AMENDED
STATE OF IDAHO
DEPARTMENT OF WATER RESOURCES

Ident. No. 63-34021

APPLICATION FOR PERMIT

Re: Application for Permit- Request for more information

State of Idaho
Department of Water Resources
Application for Permit
63-34021

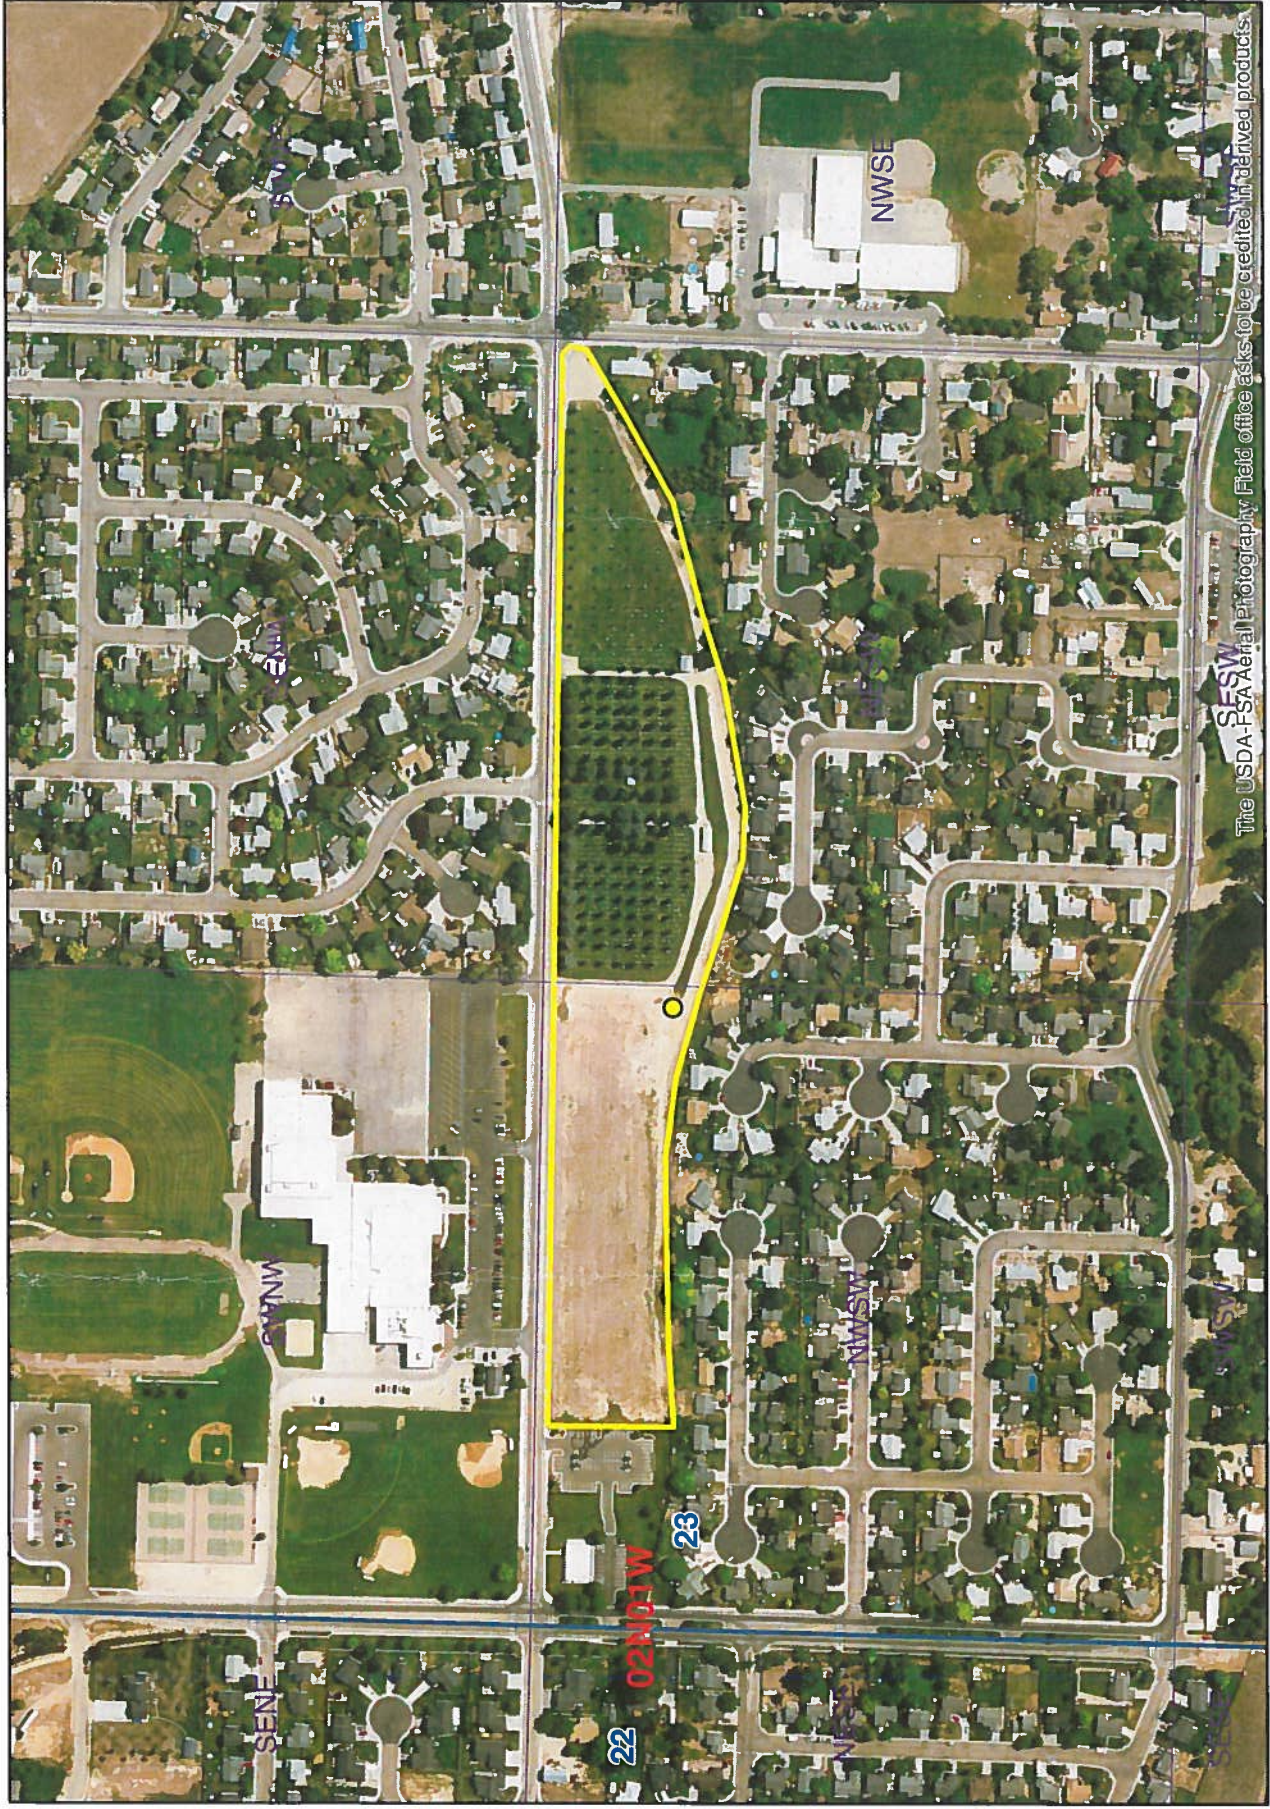
1. Section 3: The government lot was removed from the description of the point of diversion. Based on USGS quadrangle maps, your property is not located on a government lot.
2. Section 4: The beginning of the irrigation period was changed from March 15 to March 1. This is based on Department standards for the irrigation area where you are located.
3. Section 6: The description of the proposed diverting works was elaborated based on the additional information you described in your attachments.
4. Section 8: The description of the place of use was completed based on form standards. This includes rounding the acres to the nearest whole acre.
5. Section 13: A new map was attached based on more recent imagery from 2013.

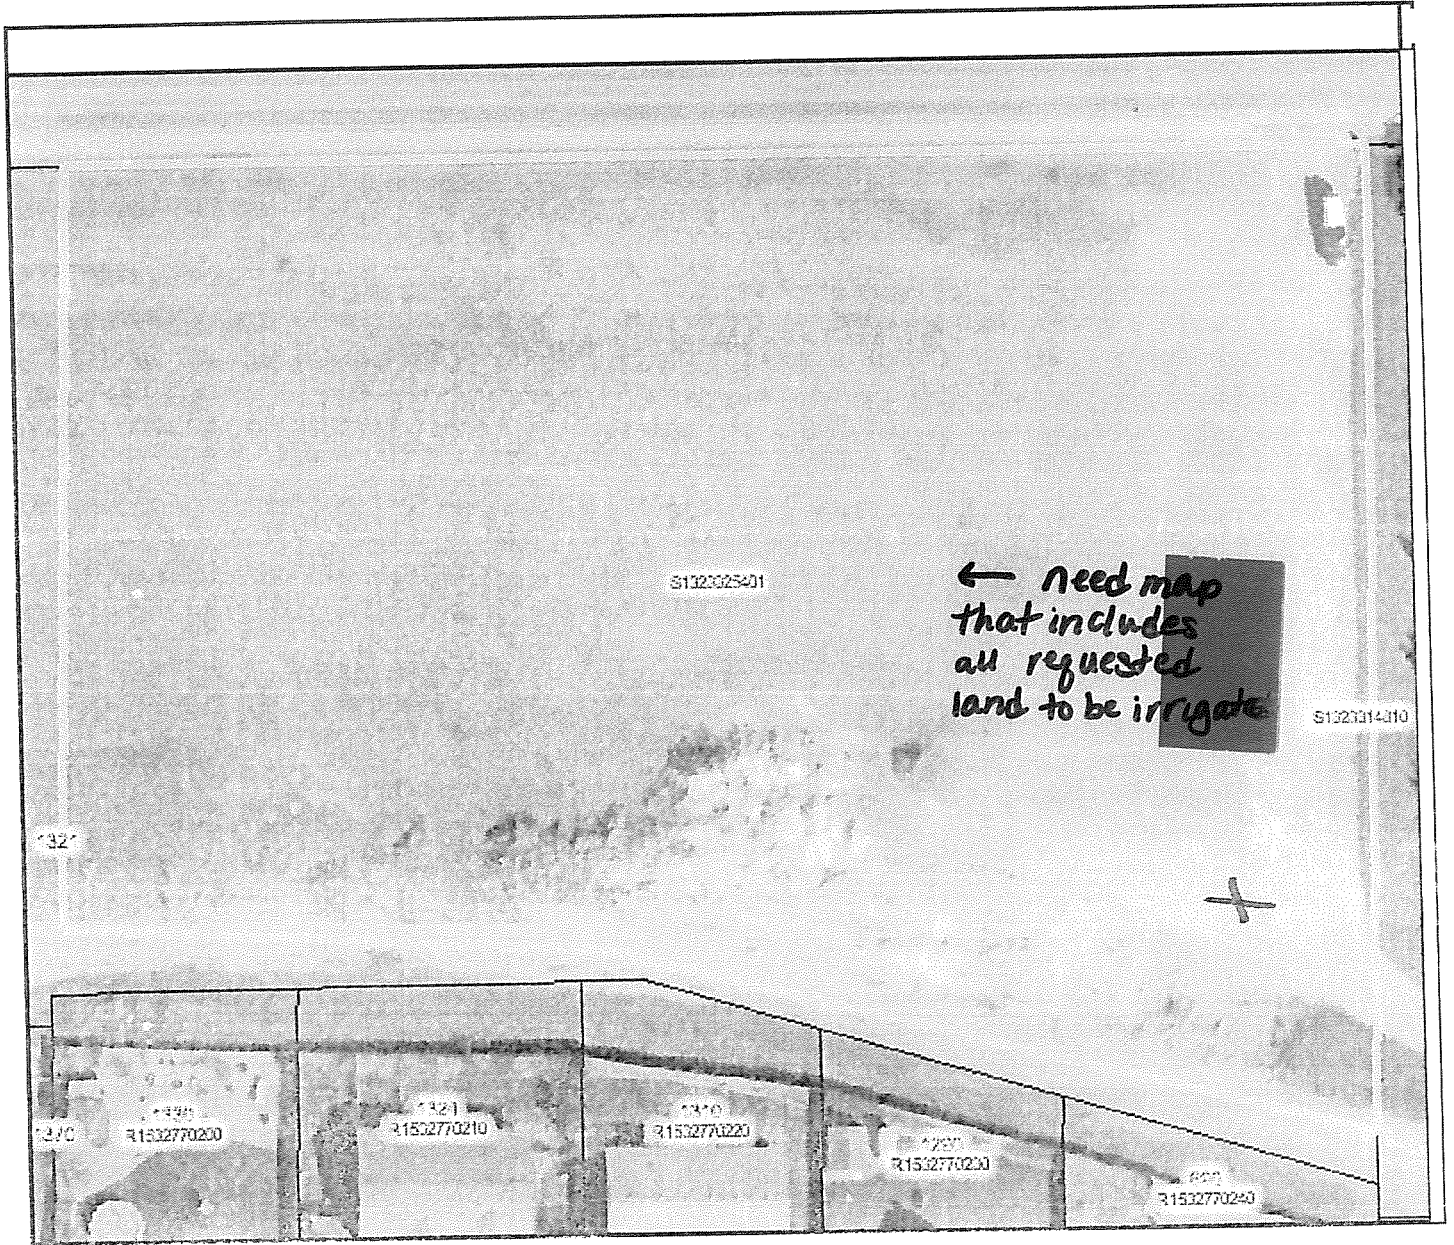
In Section 8 of the application, you describe 13 acres of proposed place of use. Section 13 of the application requires a map of the proposed project that clearly identifies the proposed point of diversion, place of use, section number, township, and range. The map you included only shows 2 acres, which is 11 acres short of the total you applied for. We need a map that includes all of the area you are planning on developing under this water permit. This map also needs to include the legal description (township, range, section) of the land so we can cross-check its location with your description.

Finally, there needs to be some clarification and possibly amending of the number of acres you wish to irrigate. Section eight (8) of your application requests 13 (which we would round from 13.173) acres to be irrigated. In your attached personal narrative, you have described 5.9 (rounded from 5.849) acres of undeveloped ground. Where are the additional 7.1 acres you wish to irrigate? Please update section 8b and describe how many acres are in each quarter quarter. Section 13 of the application requires a map of the proposed project required. Your attached map includes a visual of 2.0 (rounded from 1.97) acres out of the total 13 acres requested. Please update your map to include the point of diversion as well as place of use for all 13 acres.
